Product Change Notification

Change Notification #: 113252 - 00
Change Title: Intel® Server System R1208GZ4GC
PCN113252-00, Product Design
Update the System Rear Panel and 750W
Common Redundant Power Supply
Date of Publication: September 23, 2014

Figure One

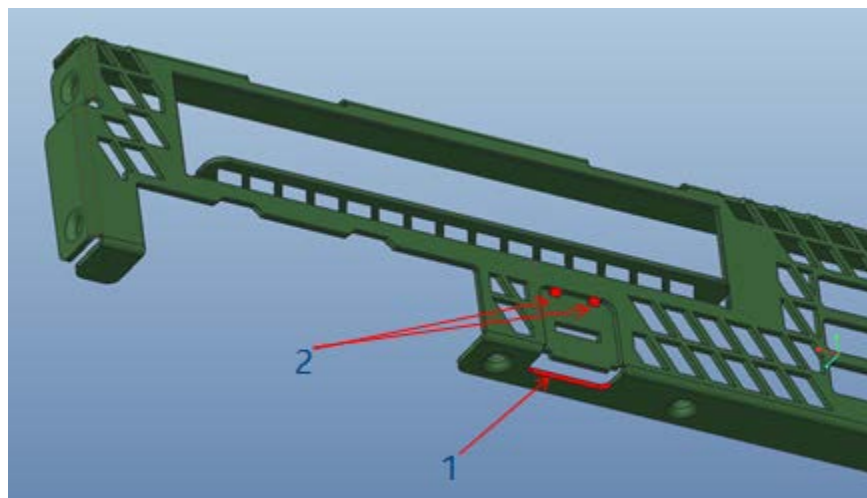
1. Add a connection at the bottom of the RMM4 (Remote Management Module 4) slot to improve structure strength. See item 1 in the Figure One.
2. Update the one big center joint to two smaller joints so that the joints will not conflict with the LAN cable connector latch. See item 2 in the Figure One.

Figure Three

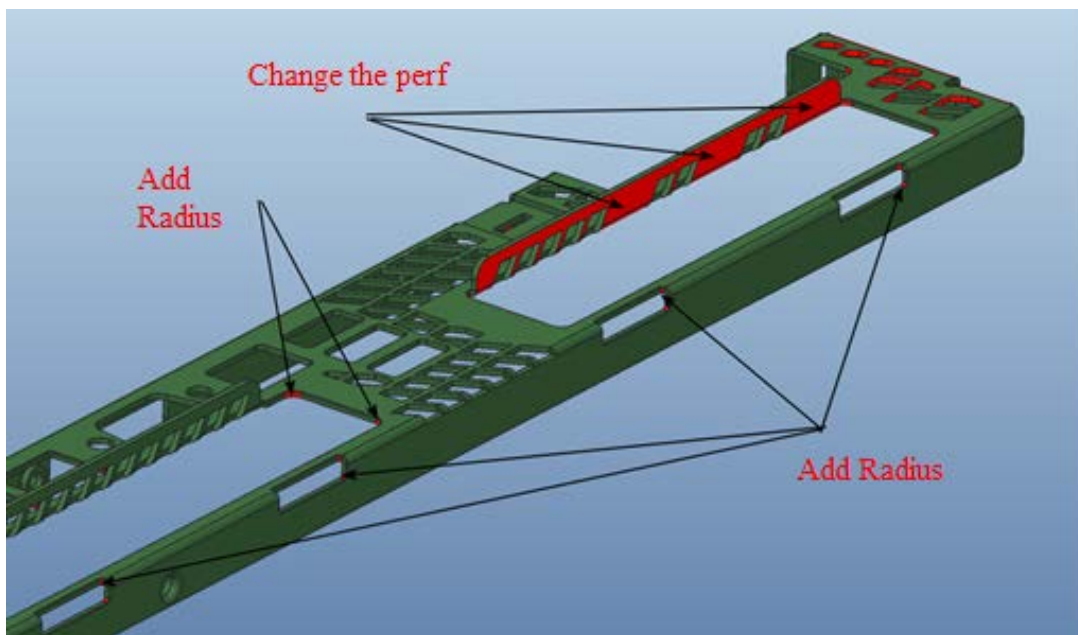
4. Update the perf and add radius to improve structure strength. See the Figure Three and Four.

Figure Five

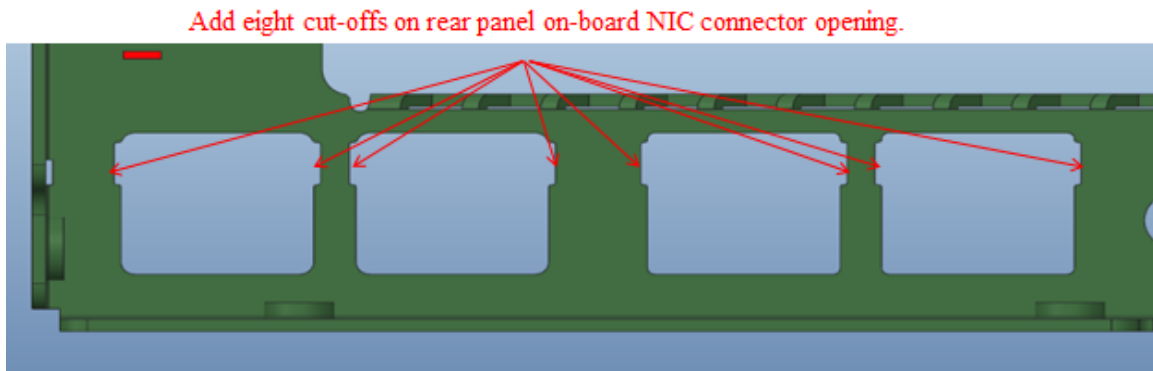
5. Add eight cut-offs around the on-board NIC (Network Interface Controller) openings to improve the LED visibility. See the Figure Five.
